Docket Number:	00-AFC-01C
Project Title:	Contra Costa Power Plant Project Compliance
TN #:	214245
Document Title:	Notice of Determination for Petition to Amend Gateway Generating Station to install a New Storm Water Treatment System
Description:	PG&E Petition to Amend requested approval to install a New Storm Water Treatment System in order to comply with the most recent National Pollutant Discharge Elimination System Industrial General Permit.
Filer:	Anwar Ali
Organization:	California Energy Commission
Submitter Role:	Commission Staff
Submission Date:	10/28/2016 4:16:54 PM
Docketed Date:	10/28/2016

**NOTICE OF DETERMINATION
PETITION TO AMEND
GATEWAY GENERATING STATION
(00-AFC-01C)**

ENVIRONMENTAL JUSTICE POPULATION FIGURE
Gateway Generating Station Power Project - Census 2010 Minority Population by Census Block

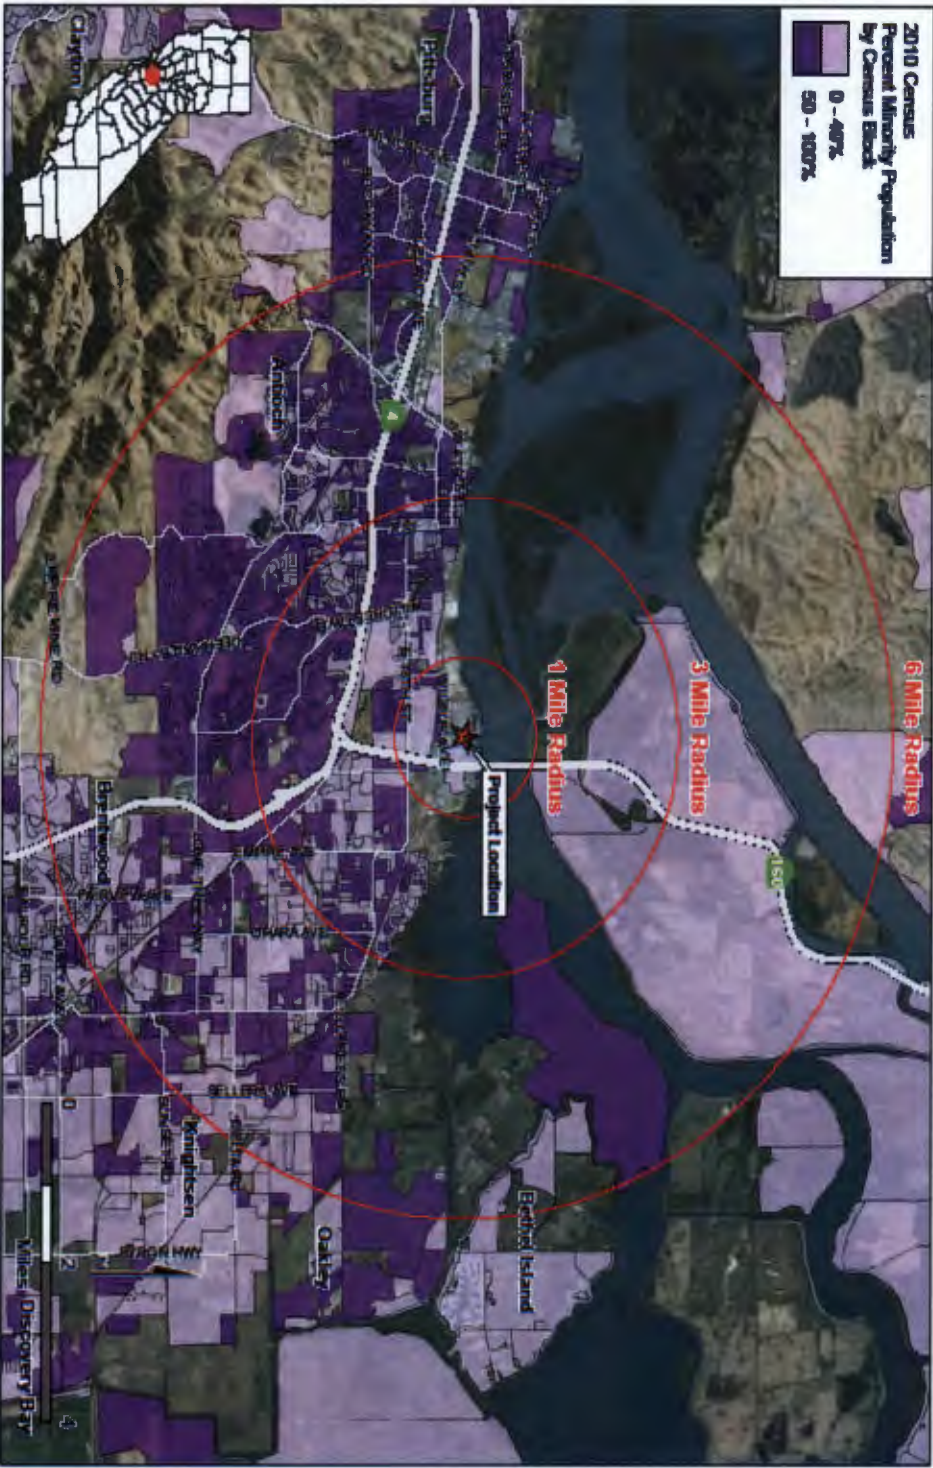
The **Environmental Justice Population Figure** (attached) shows 2010 census blocks within the six-mile radius of the GGS have a minority population greater than or equal to 50 percent. Additionally, data from the United States Census Bureau, American Community Survey in **Environmental Justice Population Table** (below) indicate that, compared to population in Contra Costa County, the city of Antioch has a higher percent of people living below the poverty level. Therefore, the population within the six-mile radius of the GGS represents an Environmental Justice (EJ) population based on race, ethnicity, and poverty as defined in the Council on Environmental Quality's *Environmental Justice: Guidance Under the National Environmental Policy Act*. Staff has determined that the proposed modifications would not cause any significant environmental impacts, and would have no significant impacts to any population within the GGS six-mile radius, including the EJ population.
